**VALENTINE GOLD PROJECT: AMENDMENT TO THE ENVIRONMENTAL IMPACT STATEMENT**

**PART 2**  
**Responses to Regulatory and Public Comments**

Figure DIET-05.1      Option 1 – Permeable Reactive Barrier

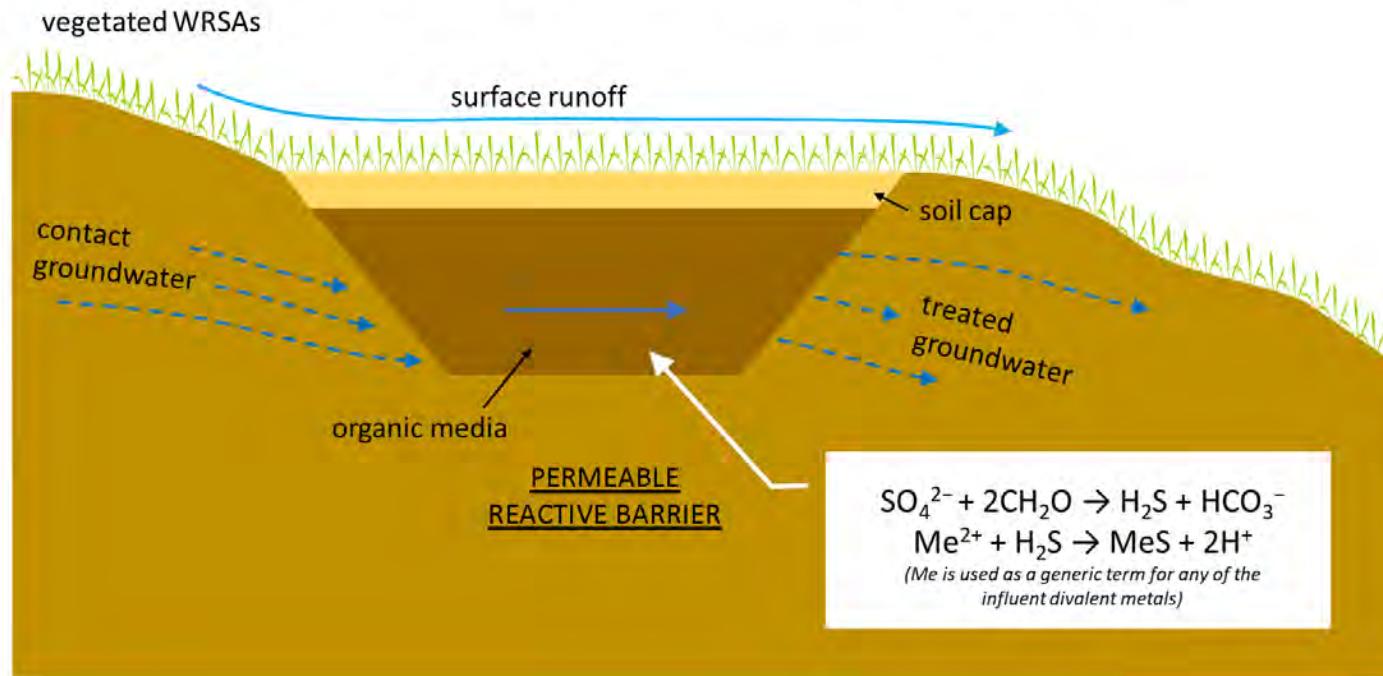
ID:	DIET-05
Expert Department or Group:	Mines Branch
Guideline Reference:	Section 4.1.10 Environmental Management: The entire project should be designed with closure in mind.
EIS Reference:	Section 2.6.3.3. Tailings Management Facility
Context and Rationale:	-
Information Request:	<p>The tailings management facility (specifically the tailings dams) are structures requiring long term monitoring and maintenance (50 years+). At some point, the dams ultimately become the responsibility of the province to maintain. As it is stated the tailings will be non-PAG, the EIS must present a detailed plan for the closure of the TMF that includes the potential reclassification and decommissioning of the tailings dams.</p>

ID:	DIET-05
	<p><u>Seepage Treatment Option #1 (Figure DIET-05.1)</u></p> <p>The collection ditches would be plugged at intervals to prevent flow down the ditch and converted to sub-surface PRB trenches. In closure, the TMF will be covered with soil and vegetation and therefore shed rain/runoff with non-contact water. However, a portion of precipitation will infiltrate and form seepage. The subsurface PRB would backfill the rock-lined ditches with carbon-rich organic material (e.g., compost) to promote sulfate reducing conditions and subsequent precipitation of metal sulfide solid phases. Groundwater would passively flow through the compost mixture where dissolved metals would be removed via iron sulfide precipitation reactions. Under reducing conditions, sulfate-reducing bacteria convert sulfate to sulfide by catalyzing the oxidation of organic carbon producing hydrogen sulfide. Divalent metals would precipitate in the presence of high concentrations of hydrogen sulfide to form the highly insoluble iron sulfide precipitate.</p> <p>A soil cap (minimum 30-cm) would be installed over the surface of the PRB trench to prevent oxygen diffusion into and water flow out of the reactive mixture. Rip rap would be installed over the surface, where necessary, surrounding the PRB collection chamber to prevent scouring and erosion from the conveyance of non-contact runoff to the surrounding undisturbed ground.</p> <p>The subsurface PRB would continue to receive contact seepage, albeit at a reduced seepage rate due to the presence of the soil and vegetation cover over the tailings. The contact seepage would migrate through the subsurface zone of the trench (smallest proposed ditch class is trapezoidal with 1 m depth, 1 m base width, and 2:1 side slopes), through the PRB under anaerobic conditions where metals removal through sulphidic precipitation can occur. Seepage water would then outlet through the opposite side of the trench to the downgradient and outside receiving groundwater environment. Soil for the trench cover and soil plugs that would be placed in the existing ditches to promote transverse seepage migration across the trench would be available as ditch excavation sidecast material proposed in operation as shallow earthen berms.</p> <p>The rate of seepage migration across the subsurface trench is constrained by the seepage inflow and outflow rates which are based on local soils characteristics, hydraulic conductivity and gradients. The average linear groundwater velocity is estimated at between 0.126 m/year to 12.61 m/year. Thus, the seepage residence time through the subsurface trench would range from a few days to weeks, which is sufficient retention time to promote sulphate reducing conditions and the subsequent metal sulphide</p>

ID:	DIET-05
	<p>precipitation reactions. Due to the predictions that seepage quality would not be substantially elevated above the MDMER or Canadian Water Quality Guidelines for Freshwater Aquatic Life, the PRB would be sized based on a minimum hydraulic retention time (HRT) of 24 hours, which is expected to be sufficient.</p> <p><u>Seepage Treatment Option #2 (Figure DIET-05.2)</u></p> <p>For this scenario, the perimeter collection ditches would be converted to subsurface French drains to allow contact seepage from the covered stockpiles to passively intercept seepage and convey seepage downgradient to the collection pond. The collection pond would be converted to an engineered wetland or subsurface passive bioreactor, essentially creating treatment with greater capacity and HRT than the PRB.</p> <p>Metals entering the engineered wetland would be initially removed via sedimentation and filtration processes. Following these physical processes, metals would be buried and sequestered in the wetland sediments via adsorption and chemical precipitation reactions. Within the wetland substrates, anaerobic conditions promote the growth of sulfate-reducing bacteria. The substrates are designed to be rich in organic matter and sulfates. Under anaerobic conditions, sulfate-reducing bacteria convert sulfate to sulfide by catalyzing the oxidation of organic carbon producing hydrogen sulfide. Divalent metals (e.g., iron, silver, copper, zinc, cadmium, manganese and lead) would precipitate in the presence of high concentrations of hydrogen sulfide to form insoluble metal sulfide precipitates. These precipitates would be removed from the water and permanently sequestered within the substrate. The average HRT in the collection ponds would be in the range of 24 hours, which is expected to be sufficient, and also may be improved using outlet controls.</p> <p>Seepage water would be monitored and would not be discharged to the environment until such time that water quality has been shown to consistently meet closure effluent criteria. The engineered wetland would use existing outlet infrastructure to the extent feasible. Once the contact water collection system is retrofitted to an engineered wetland treatment system, monitoring frequencies would be adjusted based on site conditions and performance objectives.</p> <p><u>Monitoring and Maintenance</u></p> <p>Monitoring and maintenance of the rehabilitated facilities will be carried out during operations and into closure. It is anticipated that monitoring and maintenance will be carried out during the active closure stage at frequencies similar to those required during operations. Post-closure monitoring and maintenance will be carried out at a reduced frequency</p>

Figure ECC-04.7

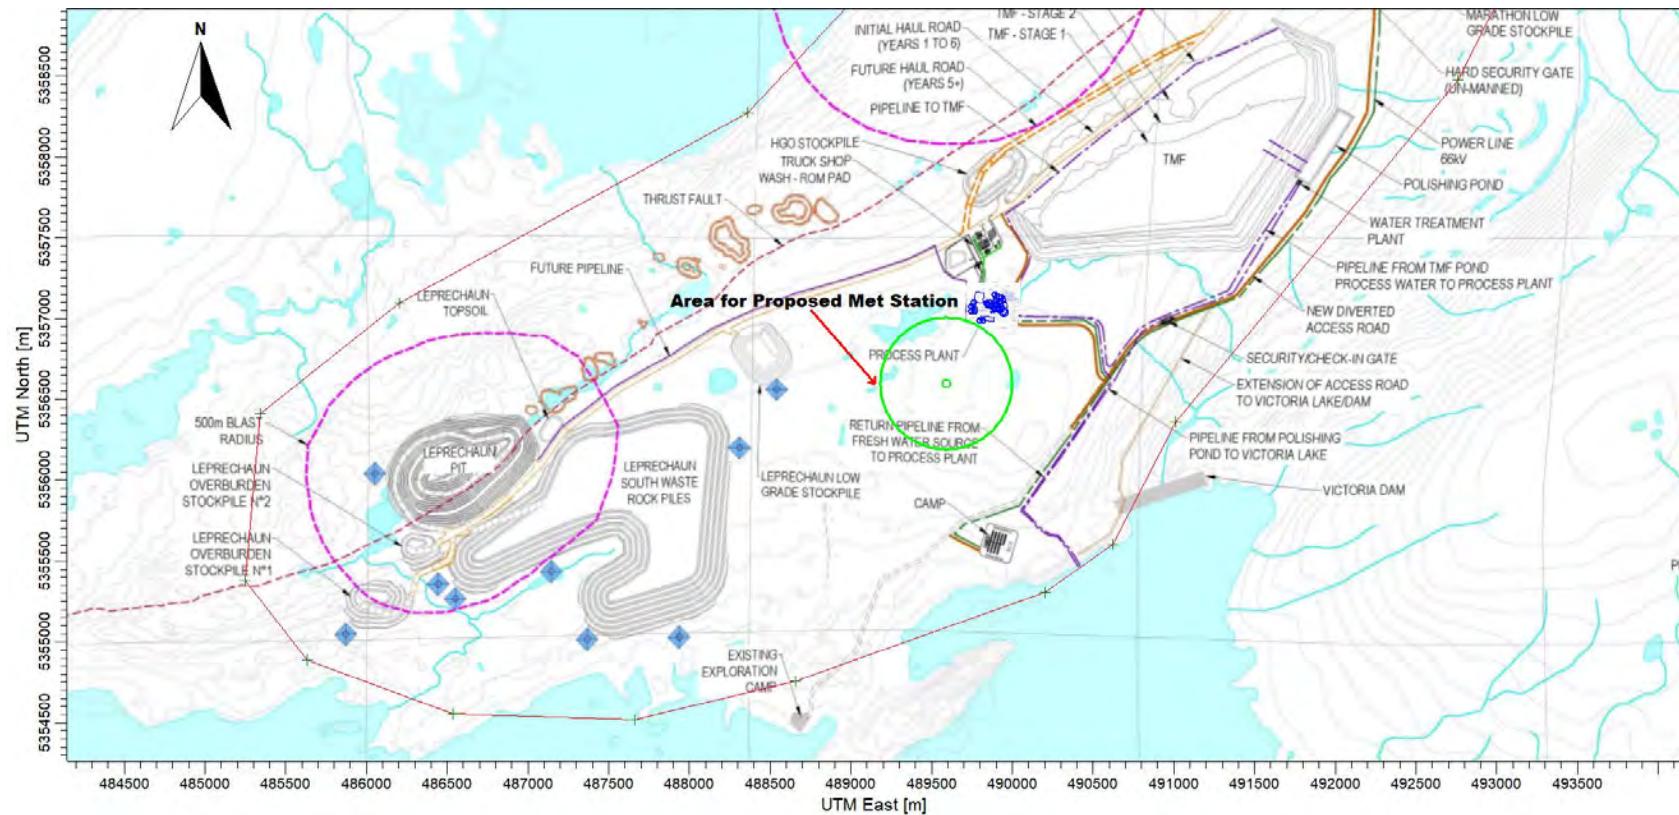
ID:	<b>ECC-04</b>
Expert Department or Group:	Department of Environment and Climate Change- Water Resources Management Division
Guideline Reference:	Section 4.2.1.3- Water Resources
EIS Reference:	-
Context and Rationale:	-
Information Request:	Section 7 Possible locations for a 100 x 100 m climate monitoring station compound should be identified.

Response:	<p>A potential location for a meteorological (met) station has been selected by Marathon in consideration of siting guidelines from Environment and Climate Change Canada and United States Environmental Protection Agency. Practical aspects have also been considered in the siting, including design of the site layout, terrain relief, the nearby surroundings, power availability, security, and capacity for data acquisition. The approximate proposed location, east of the processing plant, is shown on Figure ECC-04.1. Marathon will consult with Water Resources Management Division prior to final site selection.</p> <p>A number of technical and logistical factors were considered in identifying a potential site and will need to be considered in final site selection. Siting criteria from an equipment supplier / manufacturer were considered and will be followed, to the extent possible, during final site selection.</p> <p>A location up wind (most of the time, related to prevailing wind directions in the area) of the processing plant structures has been proposed to avoid influences on meteorological measurements from wake effects associated with air flow around the buildings, structures and/or ore storage piles.</p> <p>The winds predicted for the mine site were used to identify potential prevailing winds in the region and were extracted from the CALMET meteorological model, prepared in support of the CALPUFF dispersion modelling completed for the EIS. Additional details on the CALPUFF and CALMET modelling are provided in Appendix 5B - Dispersion Modelling Strategy of the EIS. A plot of the annual winds predicted for the mine site is provided in Figure ECC-04.2. Generally, the predicted winds prevail from the southwest, west and west-northwesterly directions. The highest and lowest wind speeds also occur most frequently from the west and southwesterly directions. Seasonal wind rose plots of the predicted winds at the site are provided in Figure ECC-04.3. For the predicted seasonal winds, the most dominant directions are from the northwest, west and southwest for all four seasons.</p>

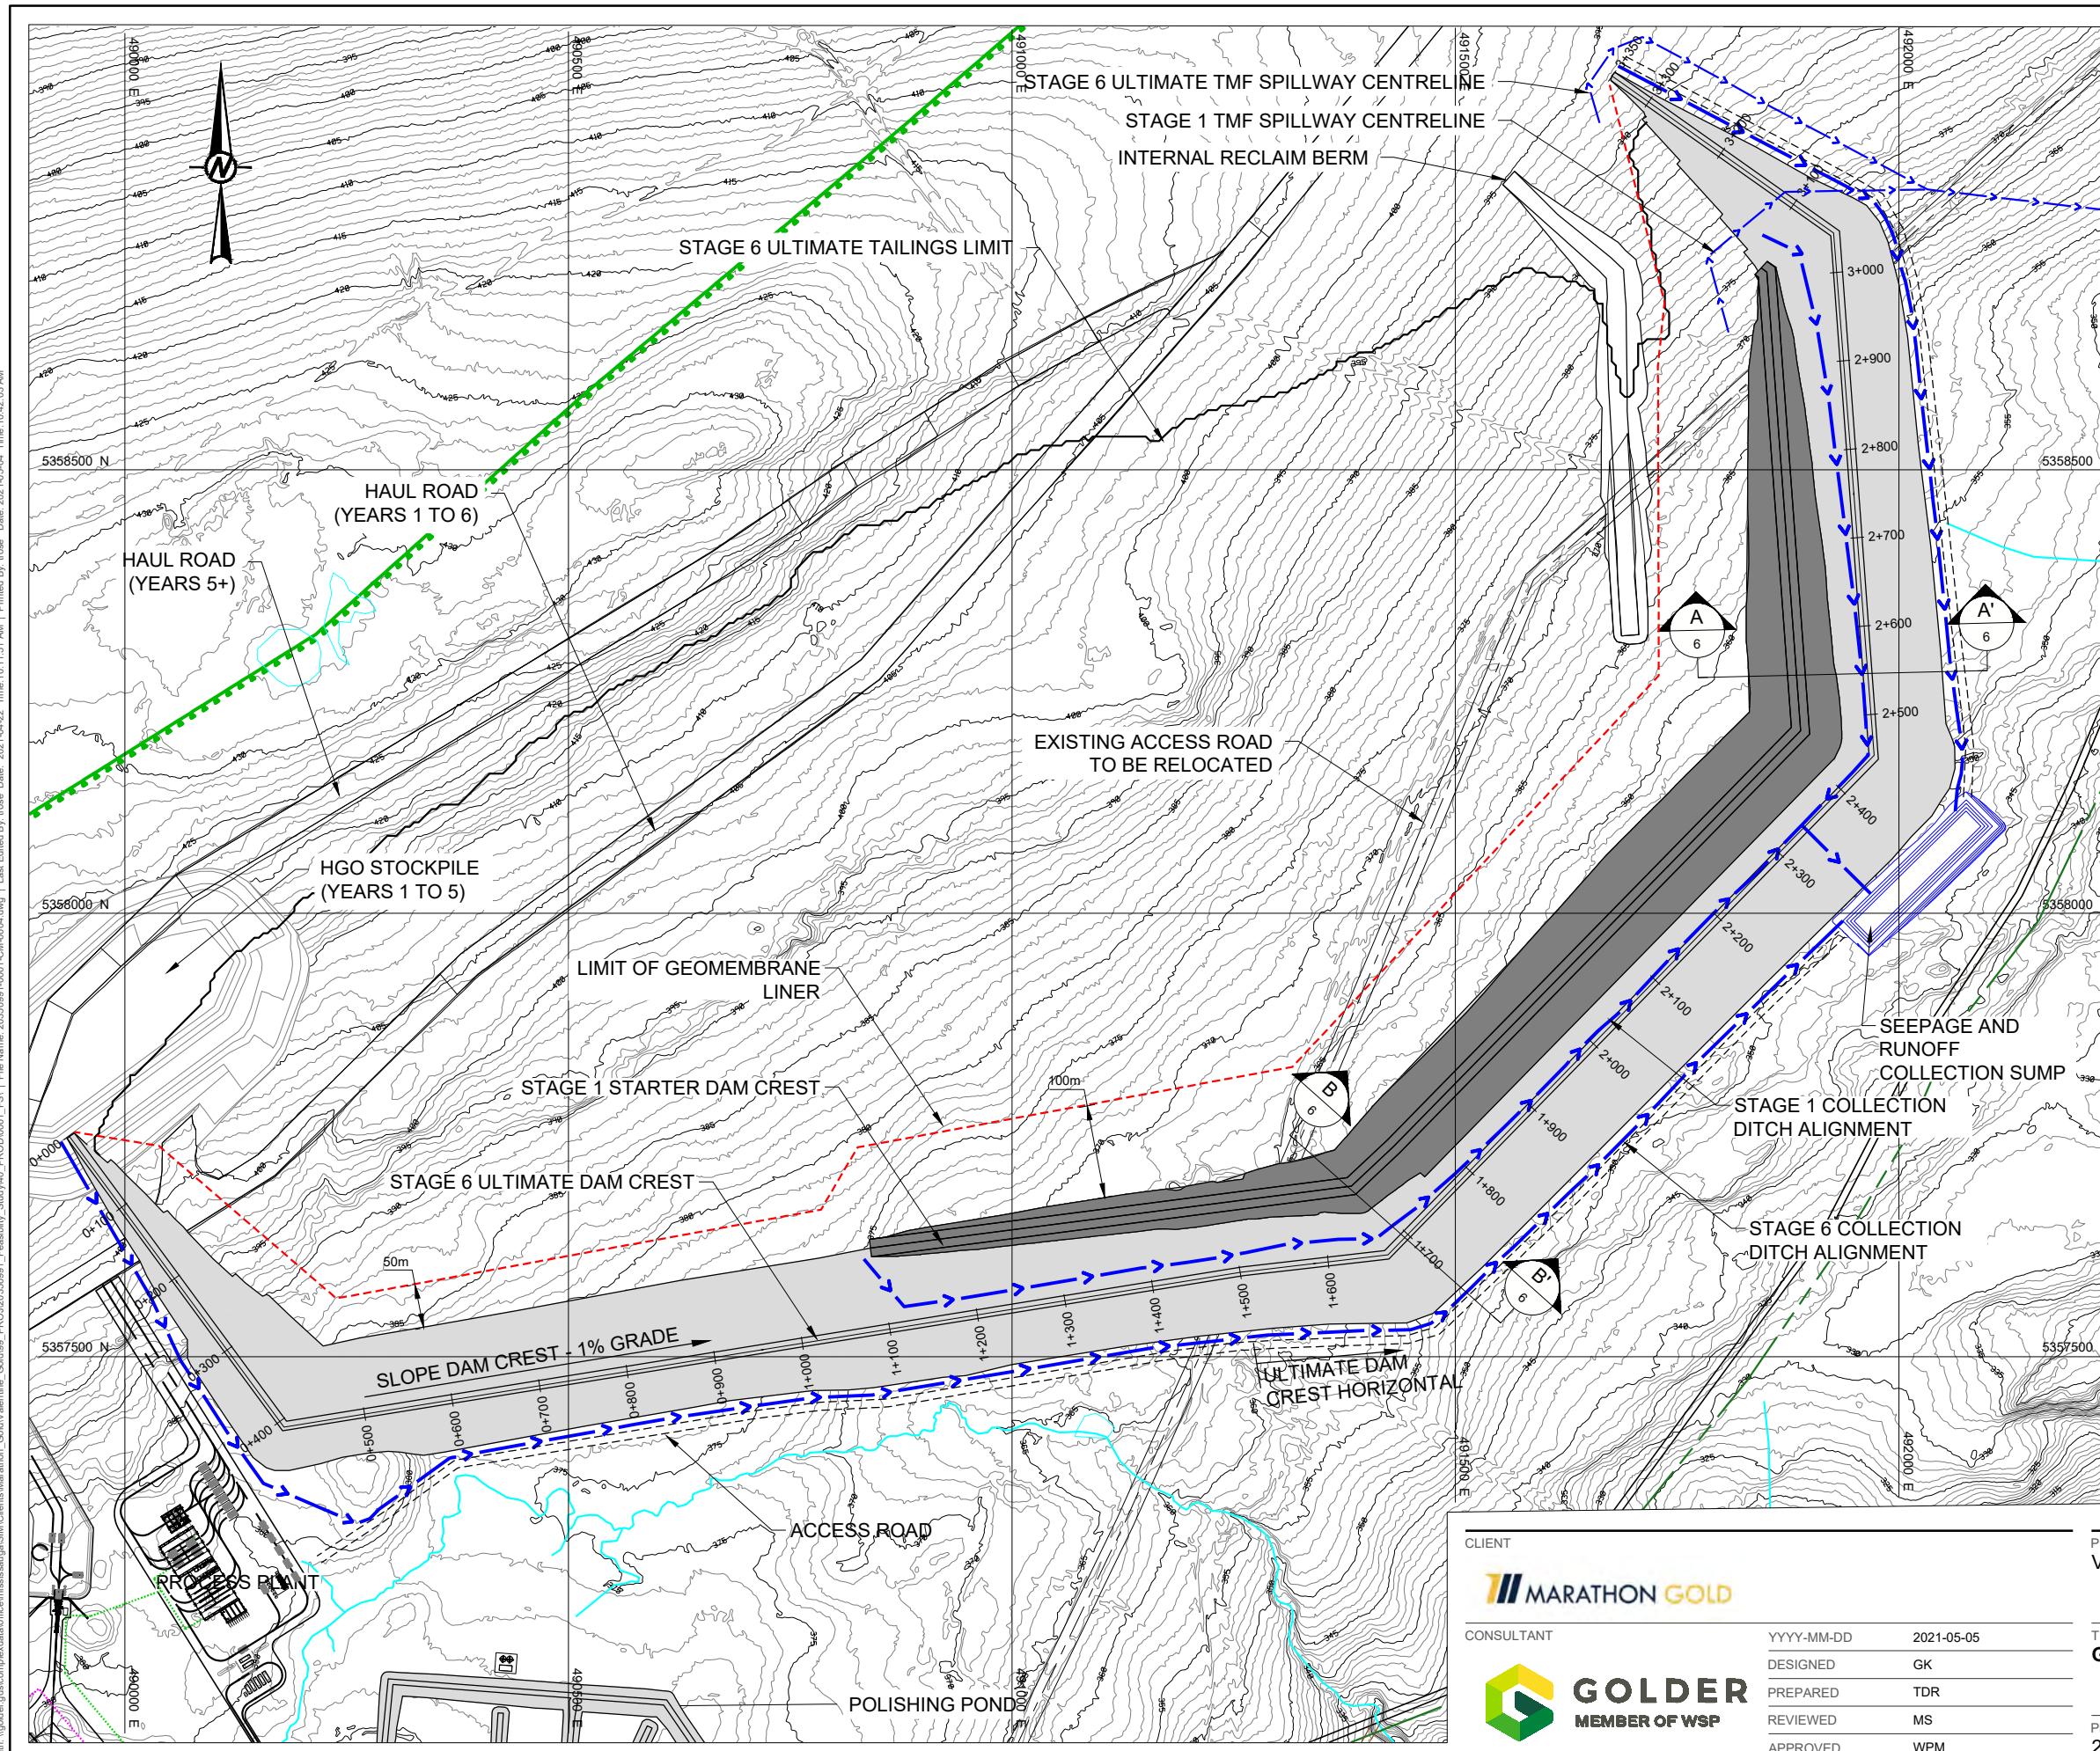
ID:	<b>ECC-06</b>
Expert Department or Group:	Department of Environment and Climate Change- Water Resources Management Division
Guideline Reference:	Section 4.2.1.1- Dam Safety
EIS Reference:	Chapter 2; Appendix 2B
Context and Rationale:	Section 2.3.4.1, pg. 2.58 Appendix 2B, Section 3.4.2, pg. 5 “Finite sampling from borehole drilling suggests the till is primarily granular and non-cohesive in nature, comprising silt, sand, and gravel containing cobbles and boulders. It is a requirement that the TMF dams are founded on compact to dense native tills and/or bedrock with low permeability characteristics to limit seepage.” Appendix 2B, Section 7.5, pg. 15 “Given the uncertainty of the foundation conditions at this time...” Section 2.5.3.1, pg. 2.106 Figure 2-44 shows overburden remaining in place at the dam foundation, except where the liner ties into the bedrock. Section 2.11.6.6, pg. 2.194 “Technical challenges to the success of a lined rockfill dam include the need for an underlying, relatively impermeable “floor” material (e.g., glacial till) to tie the liner beneath the dam to retain water upstream, otherwise the entire impoundment may need to be lined.”

Information Request:	The foundation materials described for the tailings dam and hydraulic conductivity of MW4 well near the tailings dam location do not seem optimal. There is a lack of information on the foundation conditions and the possible design options that might need to be taken (e.g., foundation grouting). What are the plans for the design of the tailings dam with respect to the foundation of the dam, sub-surface conditions and how observed sub-optimal foundation material and sub-surface conditions will be addressed? There is no information on possible foundation seepage as there is not enough information on this aspect of the dam design.

Response:	Hydrogeological and geotechnical investigations completed in 2020 included 11 boreholes and 32 test pits over the footprint of the tailings management facility (TMF). The results of the investigation show widespread compact to very dense silty sand to sandy silt till overlying bedrock which will provide the base for a competent foundation. Hydraulic conductivity testing in the overburden and bedrock was carried out and foundation seepage analysis was undertaken as part of the updated TMF design. A seepage mitigation measure has been included in the updated design of the TMF dam in the form of a geomembrane liner blanket installed on the foundation, extending 50 m to 100 m upstream of the dam to reduce seepage. Figure ECC-06.1 illustrates the extent of the seepage blanket as a dashed red line in plan view.
Appendix:	None
